# RESPONSES TO COMMENTS ON THE DRAFT SUBSEQUENT ENVIRONMENTAL IMPACT REPORT Volume 1

## Balboa Reservoir Project

SAN FRANCISCO PLANNING DEPARTMENT  
CASE NO. 2018-007883ENV  
STATE CLEARINGHOUSE NO. 2018102028

DATE: April 29, 2020  
TO: Members of the Planning Commission and Interested Parties  
FROM: Lisa Gibson, Environmental Review Officer  
Re: **Attached Responses to Comments on Draft Subsequent  
Environmental Impact Report Case No. 2018-007883ENV  
[Balboa Reservoir Project]**

#### **2040 Cumulative Conditions** (p. 3.B-91)

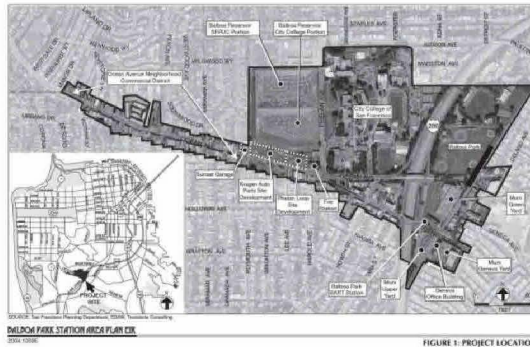
*The geographic context for the analysis of cumulative impacts is the transportation study area shown on Figure 3.B-1, p. 3.B-7.*

The geographic context for the analysis shown in Fig. 3.B-1 is limited to an eastern boundary of Frida Kahlo Way. This eastern boundary is inappropriately restrictive.

### ***“2040 Cumulative Conditions (p. 3.B-91)***

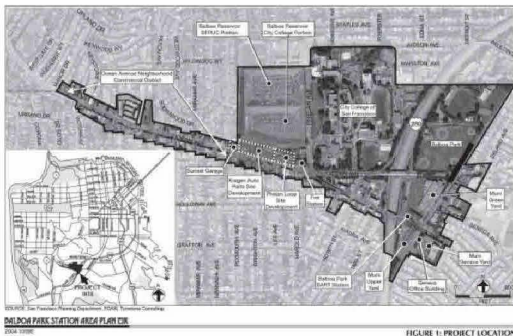
*The geographic context for the analysis of cumulative impacts is the transportation study area shown on Figure 3.B-1, p. 3.B-7.*

The geographic context for the analysis shown in Fig. 3.B-1 is limited to an eastern boundary of Frida Kahlo Way. This eastern boundary is inappropriately restrictive.

**(Revised) Figure 2-12**  
Proposed Street Type Plan

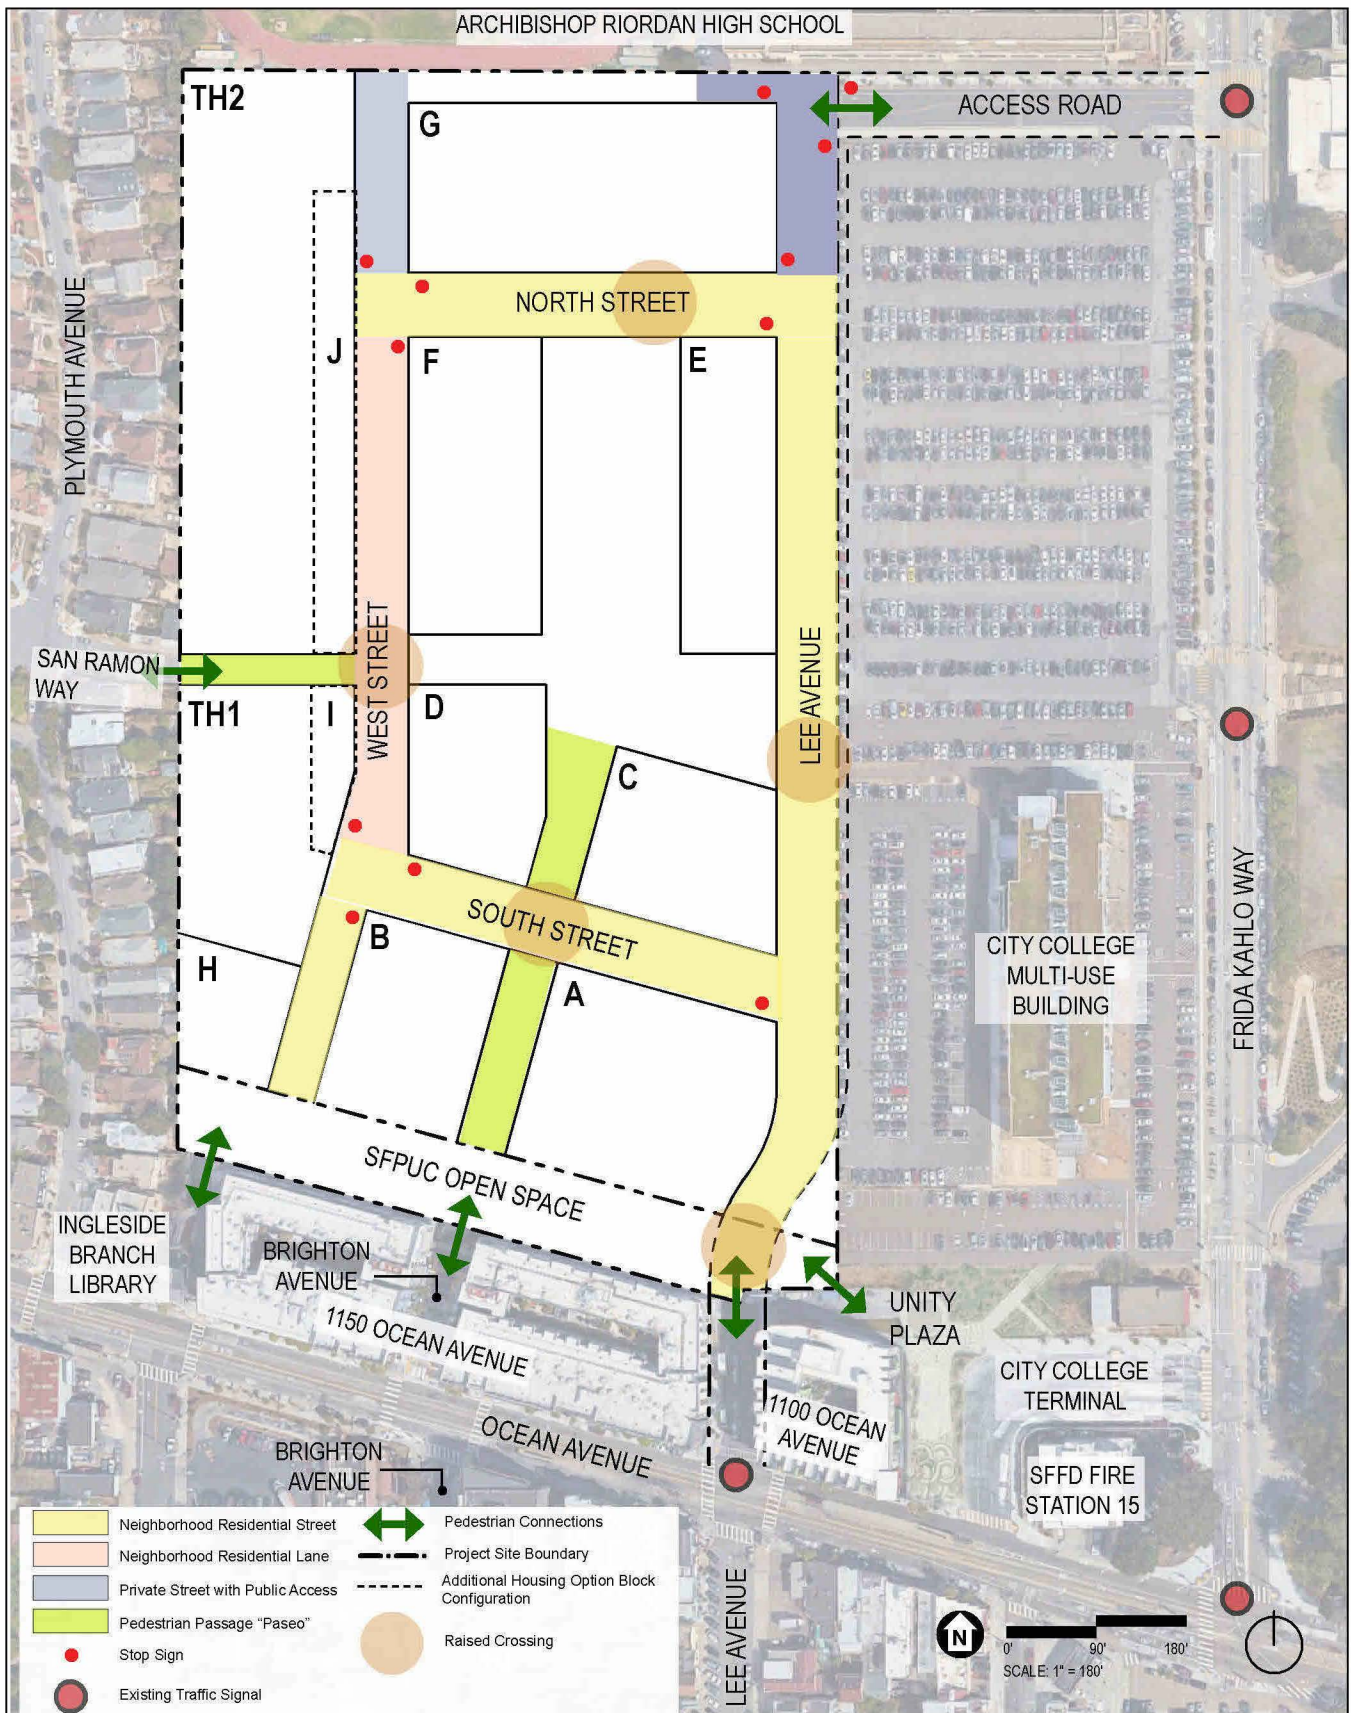
As illustrated on Figure 2-12, Proposed Street Type Plan, on draft SEIR p. 2-27, the portion of West Street that is south of South Street is proposed as a private street and the portion of Lee Avenue that is north of North Street is proposed as a neighborhood residential street. The type of street has been modified by the project sponsor such that West Street south of South Street is proposed as a neighborhood residential street, and Lee Avenue north of North Street is proposed as a private street. These revisions would only change the street ownership and would not result in changes to roadway configurations or vehicle, pedestrian, or bicycle access to and from the project site. The revised street ownership is shown in Revised Figure 2-12 in RTC Chapter 5, Draft SEIR Revisions.

The following figure has been revised to show the revised street ownership; the revised figure is provided in RTC Chapter 5, Draft SEIR Revisions.
